BRUNSWICK-GLYNN COUNTY JOINT WATER & SEWER COMMISSION April 2, 2025

PROJECT: INVITATION FOR BID NO. 25-007 Permanent Generator Installation – Project No. 801 Phase II

- ADDENDUM: FOUR (4)
- DUE DATE:Wednesday, April 2, 2025 12:00PM NOONTUESDAY, APRIL 8, 2025 12:00PM NOON

Mallory WPF

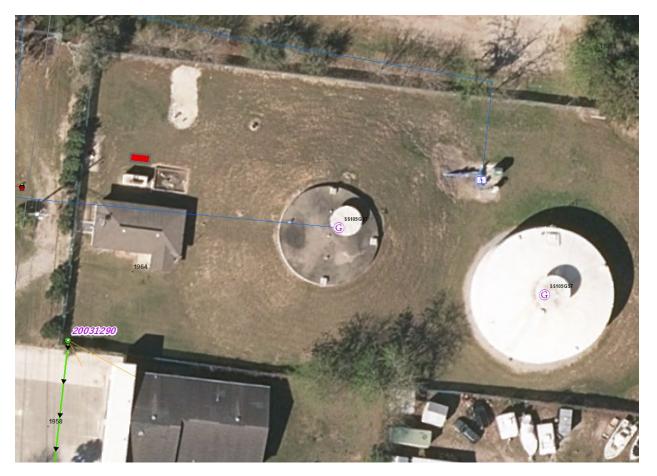
Remove existing and install in existing location preferred. Alternate location of genset shown in red.

Academy Creek WPCF Genset 3

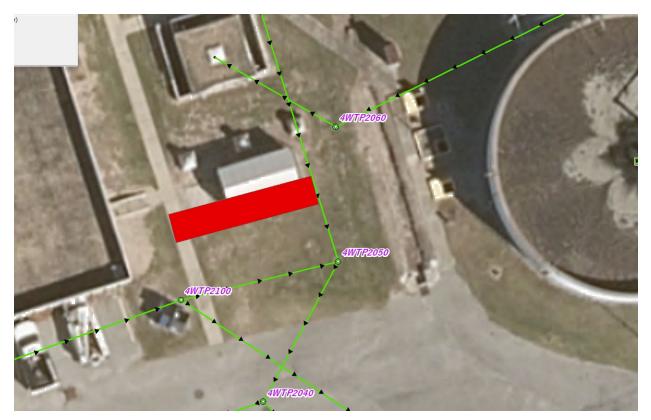
Approximate genset location in red.
